RE: ENGINEER CERTIFICATION FOR NORWEST BANK @ JOURNAL CENTER (D17-D3H) CERTIFICATION STATEMENT DATED 2/9/96.

DRAINAGE INFORMATION SHEET

TITLE: JOURNAL CENTER BUSINESS PARK
NORWEST BANK SITE
SITE DRAINAGE / GRADING PLAN
DRAINAGE CERTIFICATION PLAN

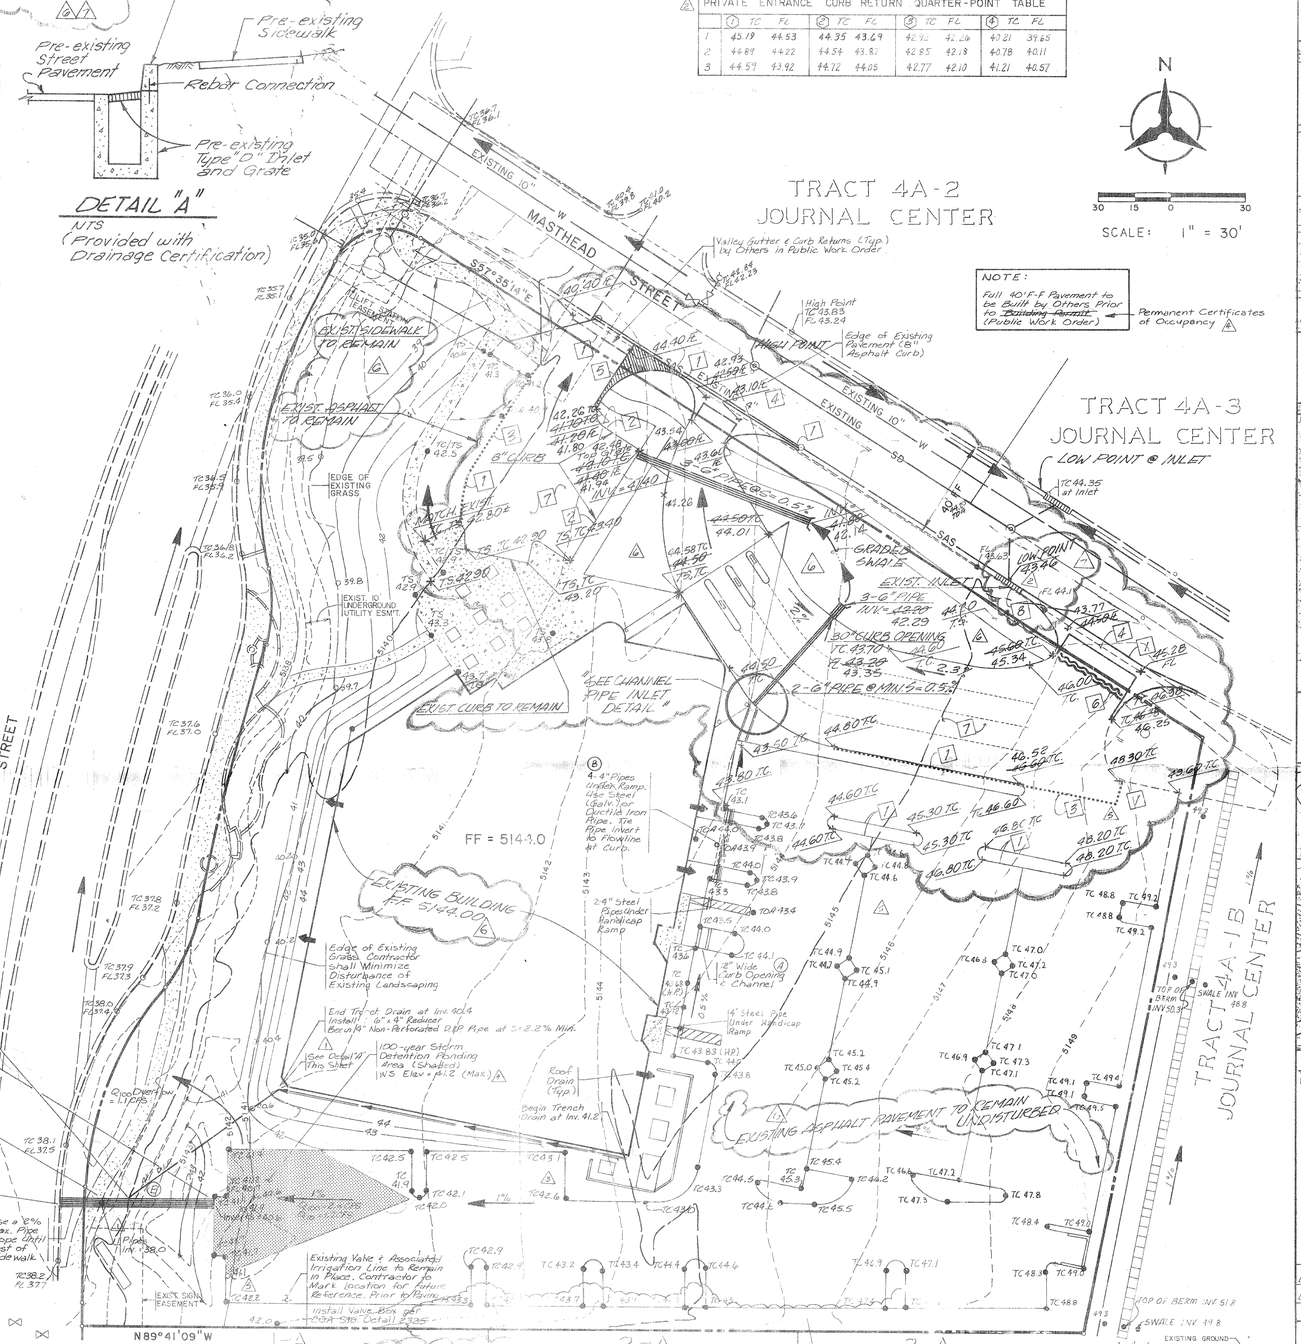
Based on the information provided on your February 9, 1996 submittal, Engineer Certification for the above referenced site is not acceptable.

A 30-Day temporary Certificate of Occupancy will be issued until the required Type "D" (double) inlet is constructed to replace Type "A".

1	PRECEDENCE SHALL BE GIVEN TO MATCHING EXISTING ASPHALT ELEVATIONS (OVER THE CALLED TC ELEVATIONS)
2	TRANSITION FROM 8" CURB TO 6" CURB.
3	LIMITS OF ASPHALT REMOVAL.
4	INSTALL NEW VALLEY GUTTER (LL JORSTE) PER CITY STD. DETAIL 24.5"
5	REMOVE AND REPLACE EXISTING CONCRETE VALLEY GUTTER PER 2415
6	WATER BLOCK
7	REMOVE EXISTING PAVEMENT
8	~~REMOVE~~ DOUBLE "D" INLET & REPLACE W/TYPE DOUBLE "A" INLET AS PER COA STD DWGS 2201 & 2202 (BY OTHERS)
	(DRAINAGE CERTIFICATION REVISION)

IN THE BUBBLED AREA LABELED AS REVISION 6, ORIGINAL DESIGN ELEVATIONS HAVE BEEN CHANGED TO ACCOMMODATE THE DRIVE-THRU LANES SHOWN.
